Service Bulletin

Bulletin No.: PI0988

Subject: Pop or Clunk Noise When Turning Steering Wheel at a Stop or Low Speeds

Models: 2010-2013 Chevrolet Impala

3423457

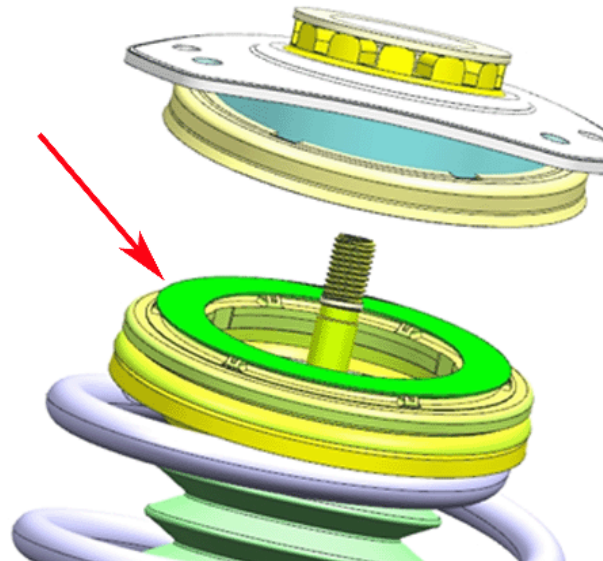
Some customers may comment on a clunk or pop type noise when turning the steering wheel at a stop or at low speeds.

Install the strut spacer as shown above. Refer to Strut, Strut Component, or Spring Replacement in SI.
